northern beaches council
PLANS APPROVED BY THE LAND AND ENVIRONMENT COURT OF NSW
PROCEEDINGS NO: 2023/238892
DATED: 5 June 2024

FOR S4.55 (8) APPLICATION

PROJECT:
PROPOSED SENIORS LIVING
4 ALEXANDER ST, COLLAROY
NSW

1 SOUTHERN BOUNDARY INTERFACE
1 : 50@A1

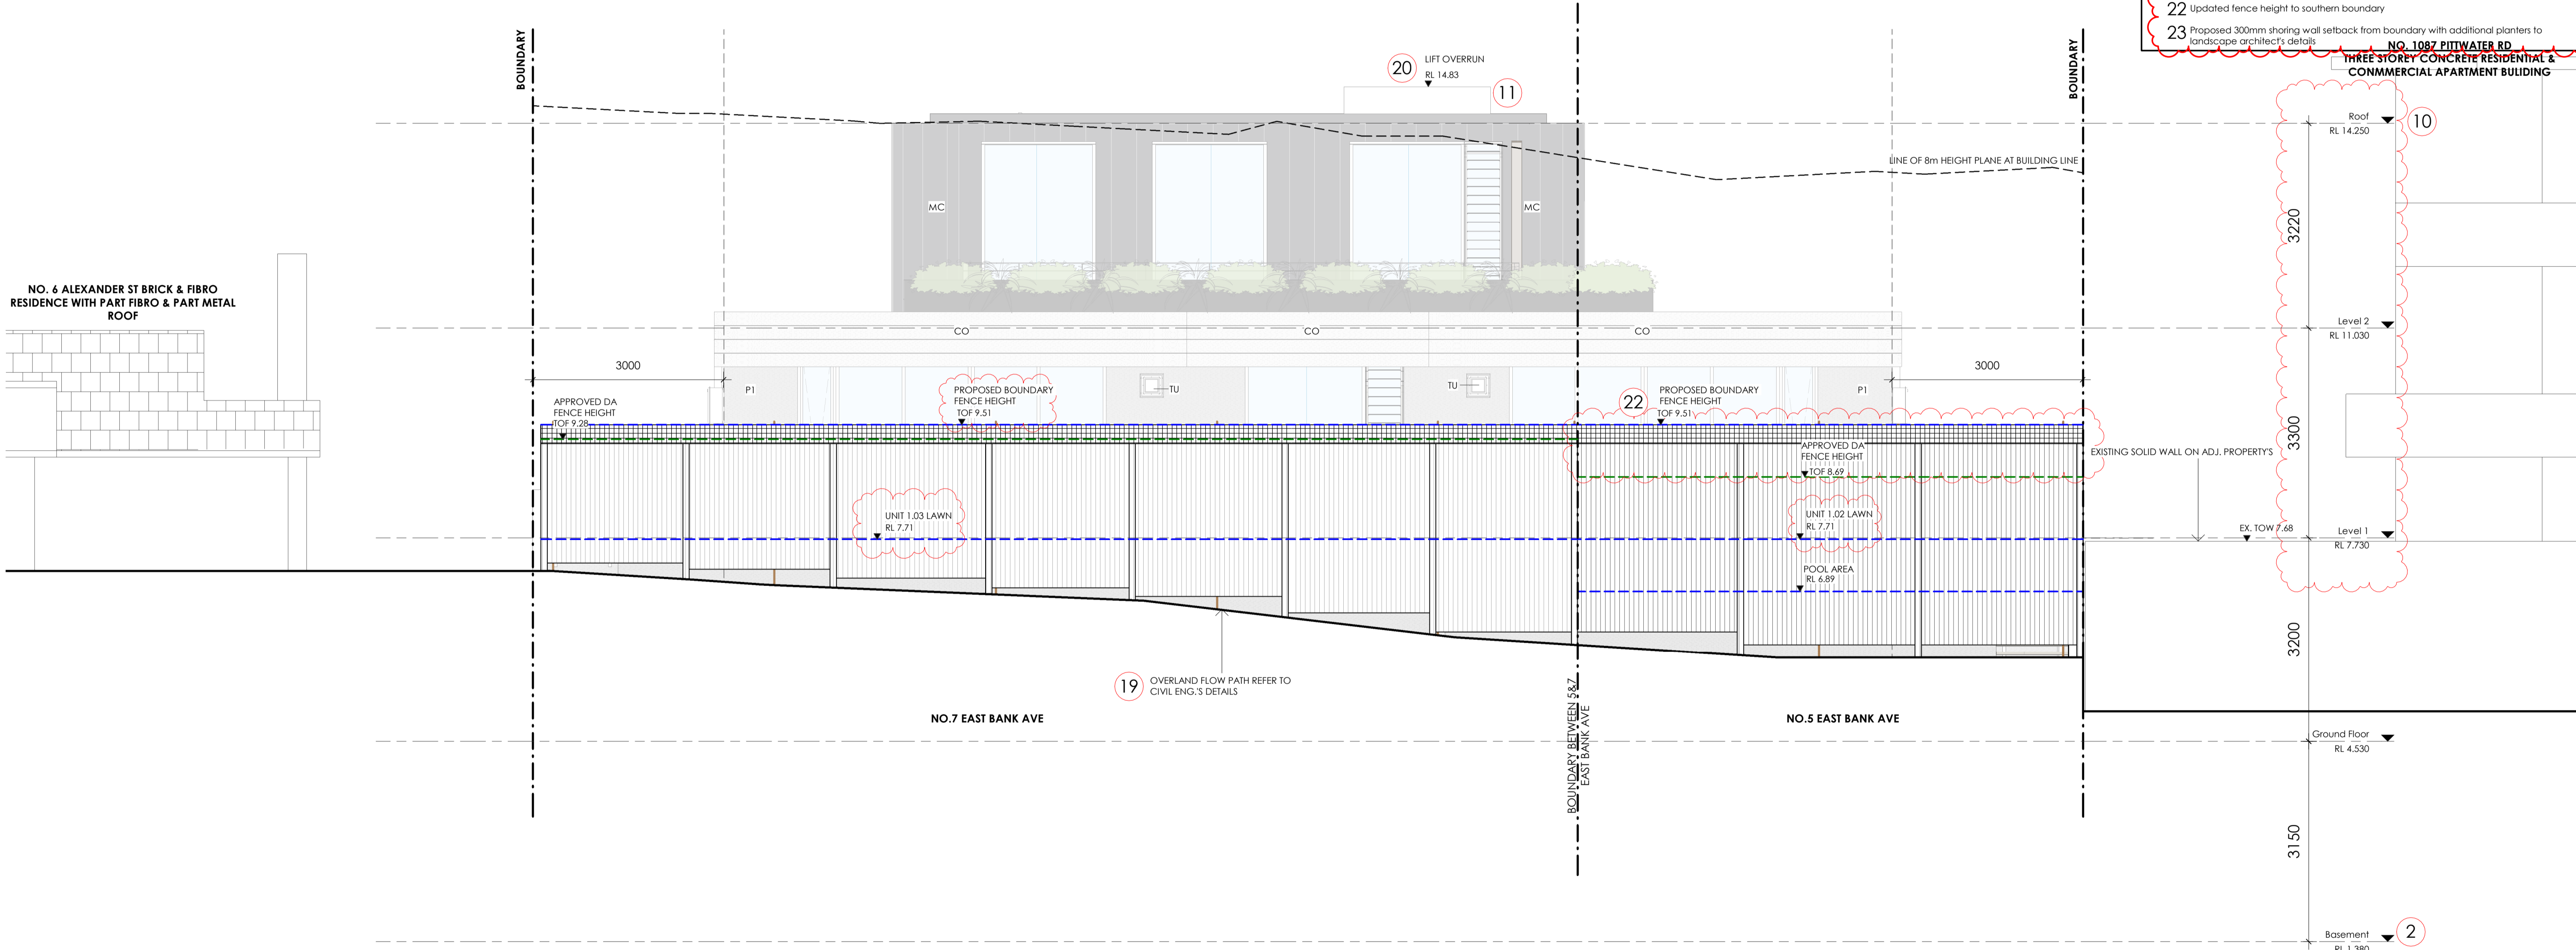
- 1 Proposed modifications to skylights including deletion of 2 skylights over unit 2.01, and updated sizes of skylights over Unit 1.02 & 1.03.
- 2 Additional storage room at basement level.

- 3 Updated interior layout generally.
- 4 Modification to facade windows openings and configurations generally.
- 5 Additional metal framed louvre awning to Level 2.

- 6 Proposed removal of flood gate from driveway and associated DA Condition 28.
- 7 Proposed external design modifications including additional BBQ benches, planters, fences and gates for maintenance access to side planters at rear (Level 1).

- 8 Updated stormwater concept design.
- 9 Associated landscape design update including:
a) Level 1: proposed updated overland flow path based on civil eng.'s assessment

b) Level 1: proposed 2 additional private plunge pools at rear
c) Level 1: Revised boundary fencing height and design at rear
d) Level 1: Revised external levels

e) Level 1: Revised external backyard
f) Ground floor: Revised front garden design to G.01 and around OSD tank area
- 10 Proposed building height increase including adjustments to floor levels to:
Level 1: RL 7.73
Level 2: RL 11.03
Roof: RL 14.25

- 11 Updated roof layout including adjustment to lift overrun structure, services layout and photovoltaic panels. Proposed deletion of DA Condition 8 as part of the proposed amendments at roof level.

- 12 Updated extent of shoring and retention generally.
- 13 Modification to proposed car parking arrangement and number of car space.
- 14 Adjustment to level 2 envelope shifting towards west generally.

- 15 Frosted glazing to level 2 ensuite window
- 16 Proposed removal of topmost roof overhang and revision to the perimeter parapet detail.
- 17 Amended landscape design at level 2 including additional planters and increase southern edge to 1m width.

- 18 Privacy screen to eastern edge of level 2 balcony at rear.
- 19 Updated overland flow path design.
- 20 Updated lift overrun level.
- 21 Updated roof layout to relocate AC units to lower levels.

- 22 Updated fence height to southern boundary
- 23 Proposed 300mm shoring wall setback from boundary with additional planters to landscape architect's details
